Wisconsin Department of Transportation

Proposal #09: 1166-05-66
Stevens Point - Wausau
USH 10 to STH 34, SB
IH 39
Portage & Marathon County

This is Addendum No. 01, which provides for the following:

ADDENDUM NO. 01

Addendum No. 01
ID 1166-05-66
Revised Sheet 15
September 3, 2026

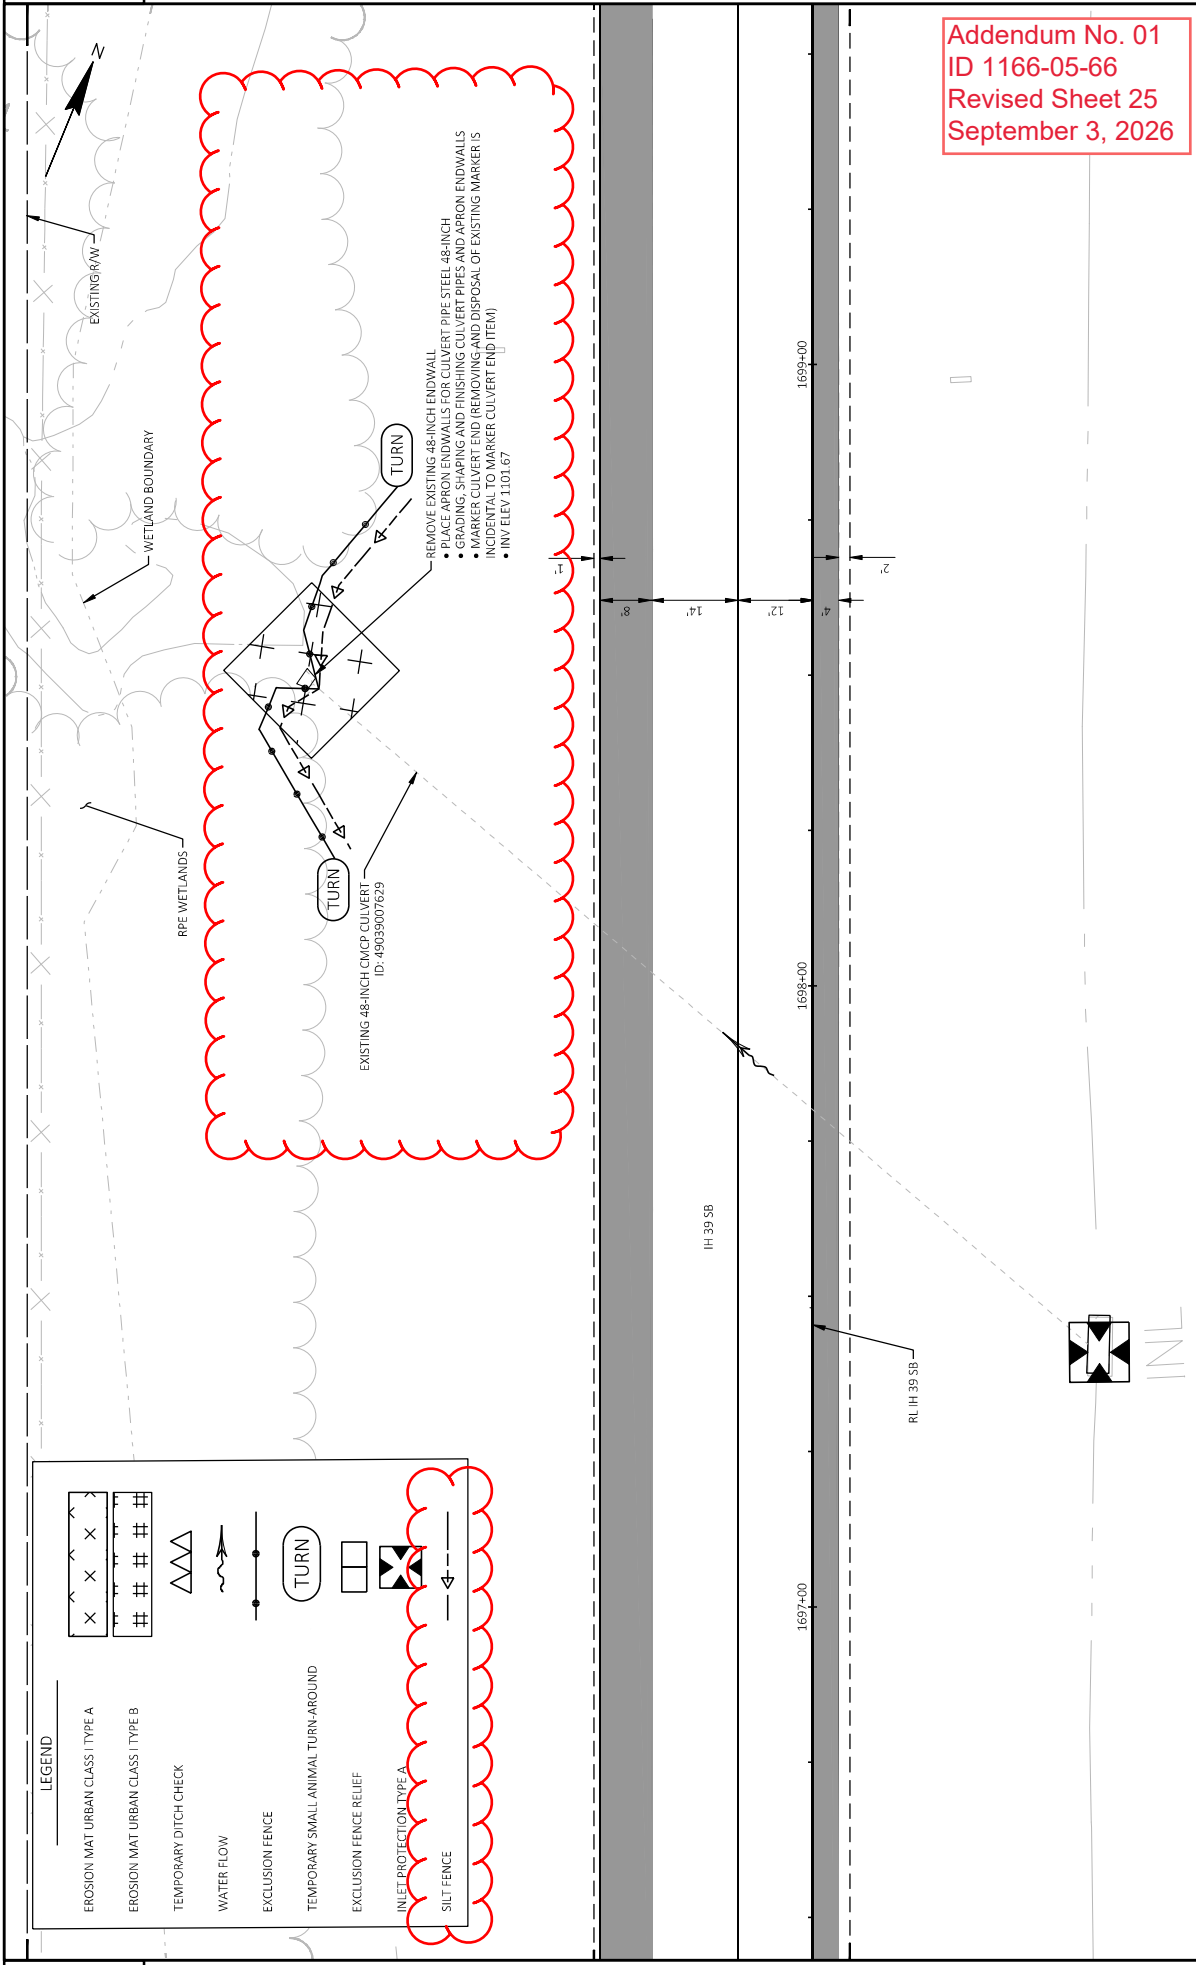
Revised Plan Sheets	
Plan Sheet	Plan Sheet Title (brief description of changes to sheet)
15	Revised construction details to remove exclusion fence details as they are now included in SDD 14D01-02 Turtle Exclusion Fence Climbing Turtle. Added construction detail for silt fence relief.
25	Revised sheet to include silt fence bid item in legend and graphically on plan details
26	Revised sheet to include silt fence bid item in legend and graphically on plan details
27	Revised sheet to include silt fence bid item in legend and graphically on plan details
28	Revised sheet to include silt fence bid item in legend and graphically on plan details
29	Revised sheet to include silt fence bid item in legend and graphically on plan details
30	Revised sheet to include silt fence bid item in legend and graphically on plan details
31	Revised sheet to include silt fence bid item in legend and graphically on plan details

NOTE: INSTALL SILT FENCE RELIEF AT
LOCATIONS OF CLIMBING TURTLE FENCE
RELIEF AS DIRECTED BY THE ENGINEER.
ROCK BAGS PAID FOR UNDER ROCK BAGS
BID ITEM

SILT FENCE RELIEF

Addendum No. 01
ID 1166-05-66
Revised Sheet 30
September 3, 2026

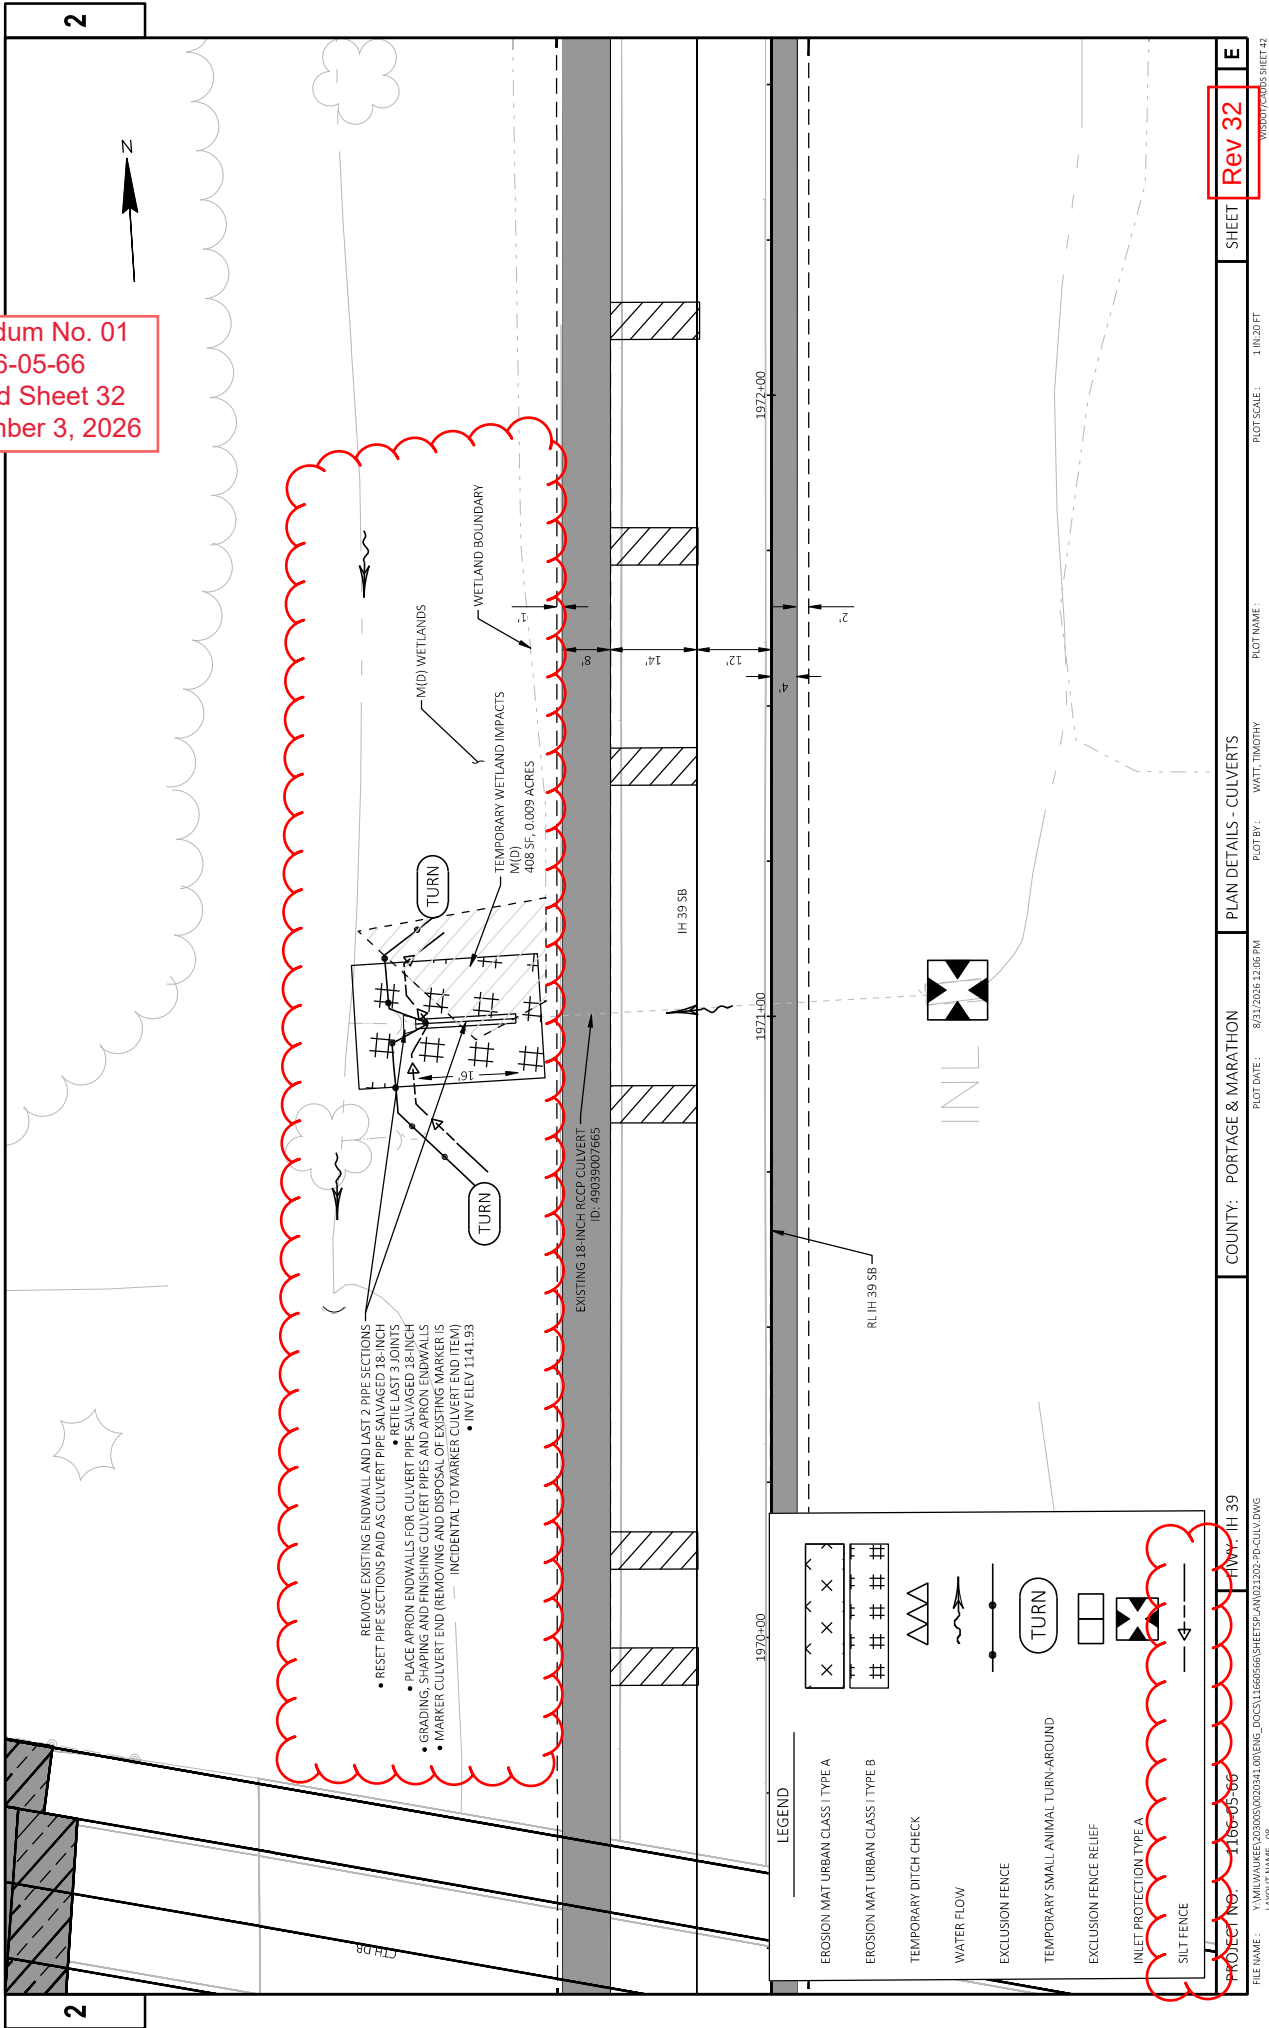
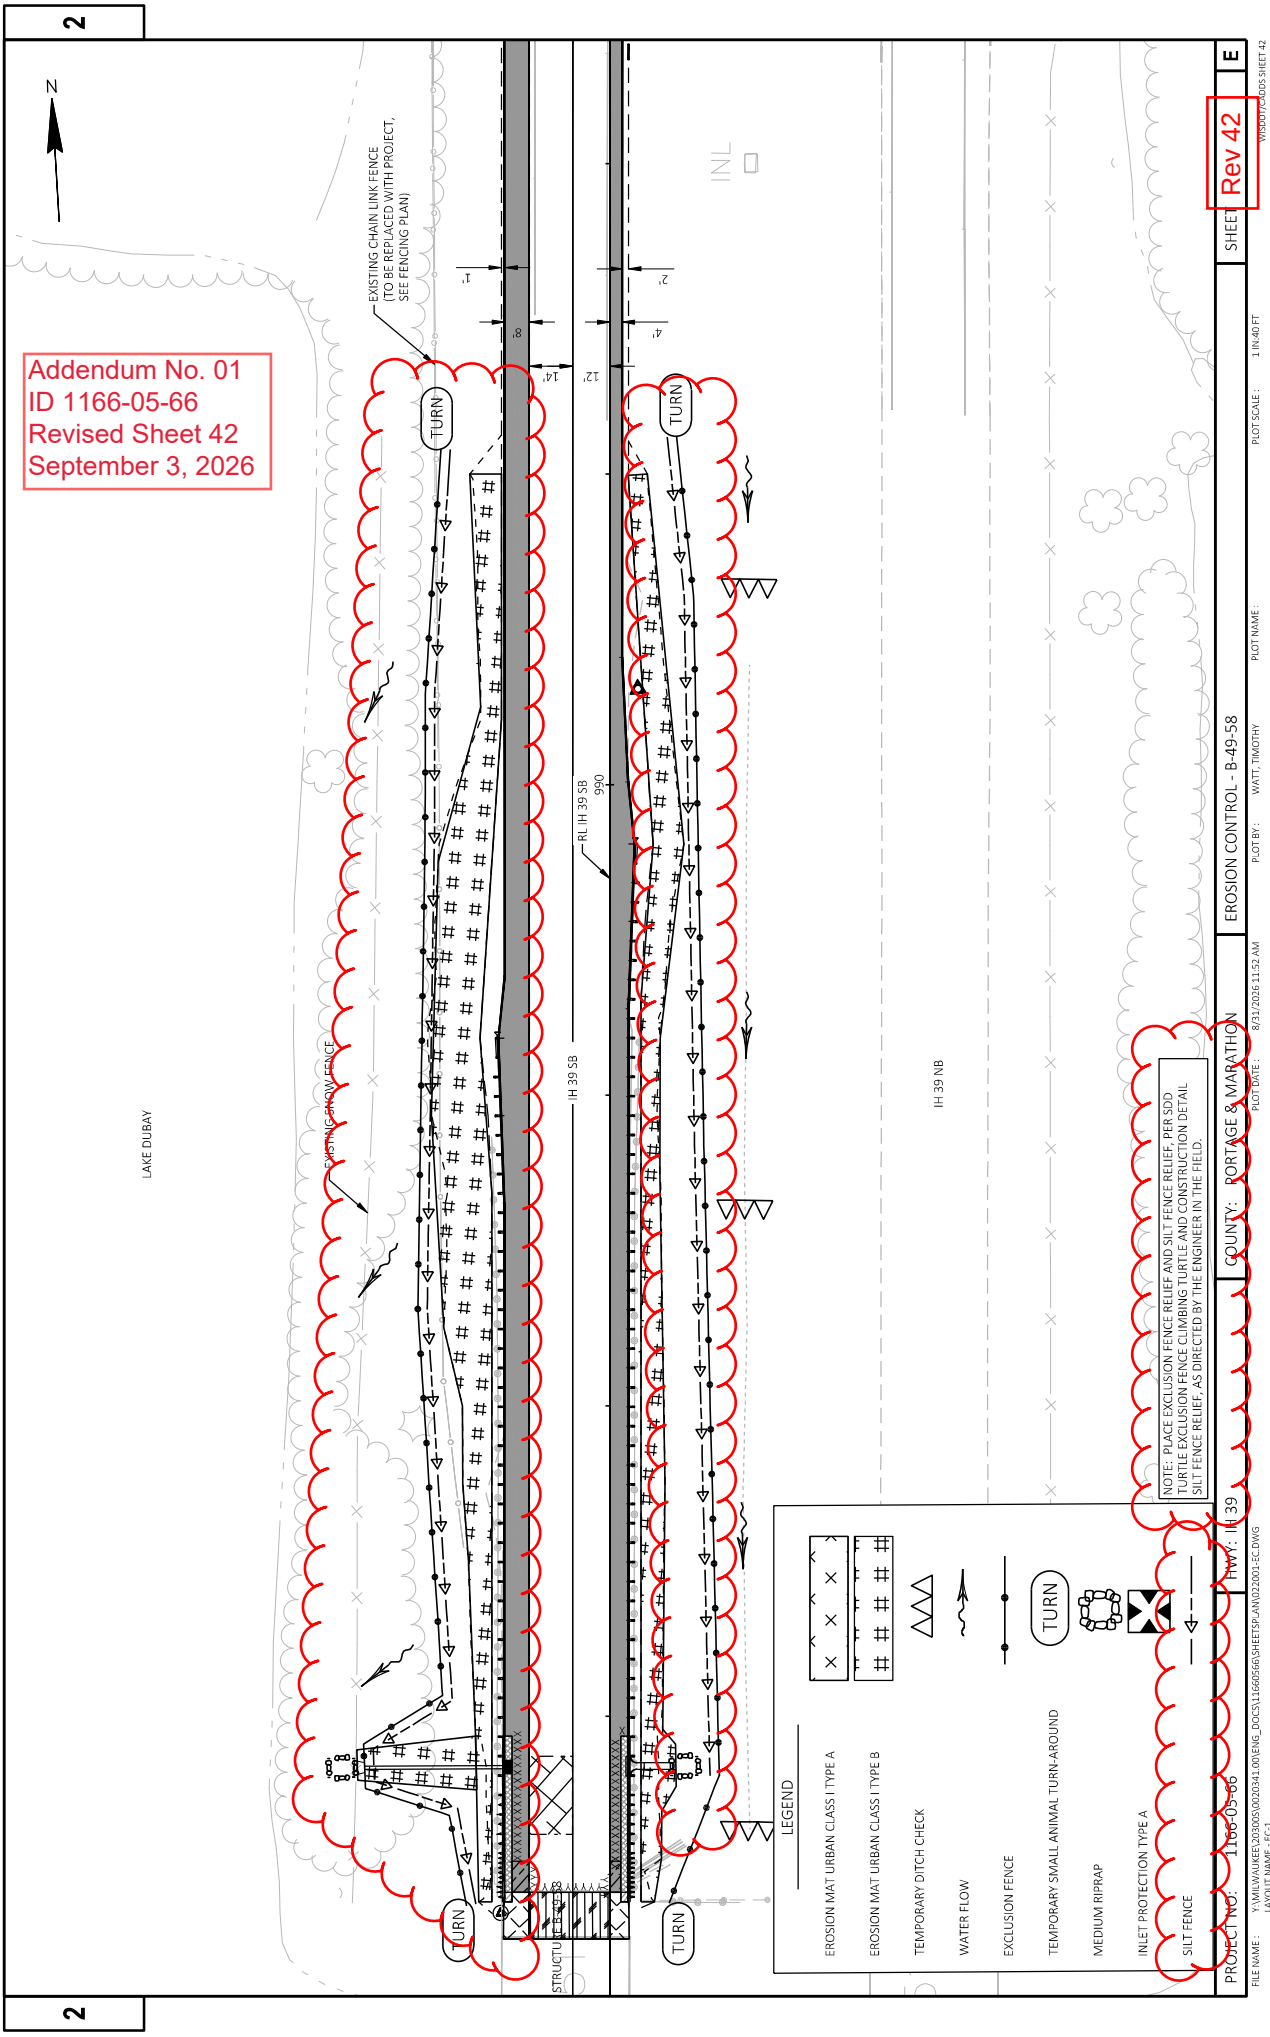
32	Revised sheet to include silt fence bid item in legend and graphically on plan details
42	Revised sheet to include silt fence bid item in legend and graphically on plan details
43	Revised sheet to include silt fence bid item in legend and graphically on plan details
44	Revised sheet to include silt fence bid item in legend and graphically on plan details
76	Added notes to coordinate traffic redirect route with Project ID 6610-00-71, on STH 34, and limitations associated with Project ID 6610-00-71.
78	Added notes to coordinate traffic redirect route with Project ID 6610-00-71, on STH 34, and limitations associated with Project ID 6610-00-71.
86	Miscellaneous Quantities Table revised to include Water bid item
89	Miscellaneous Quantities Structure Drainage Item Table revised for 12-inch pipe and endwall bid items.
91	Miscellaneous Quantities Table revised to include Silt Fence and Silt Fence Maintenance bid items. Rock bags bid item quantity revisions to include implemented Silt Fence Relief from Revised Plan Sheet 15.

Addendum No. 01
ID 1166-05-66
Added Sheet 161A
September 3, 2026

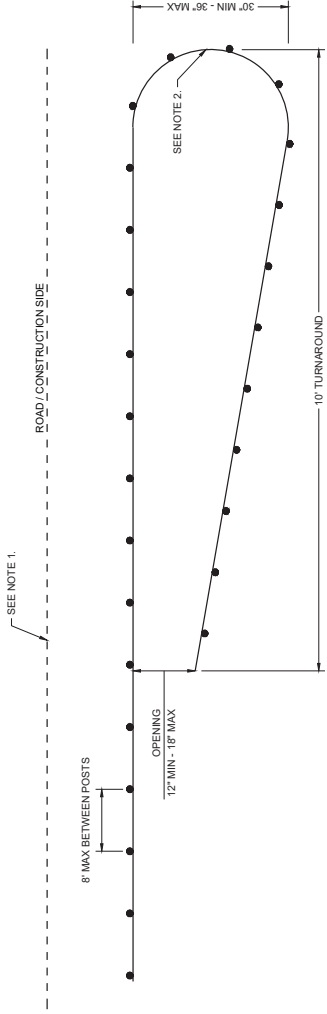
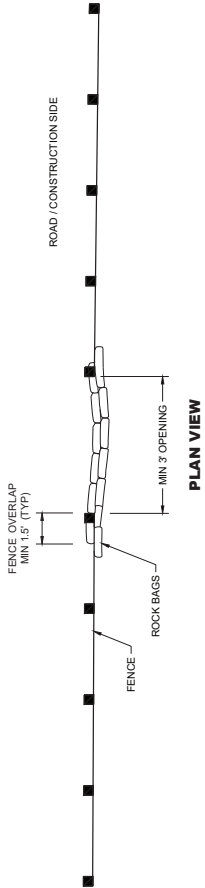
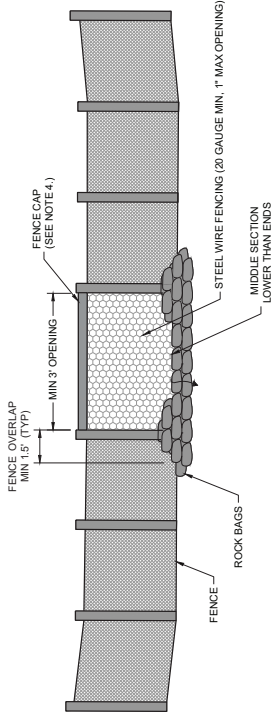
Added Plan Sheets	
Plan Sheet	Plan Sheet Title (brief description of changes to sheet)
161A	Included SDD 14D01-02 Turtle Exclusion Fence Climbing Turtle
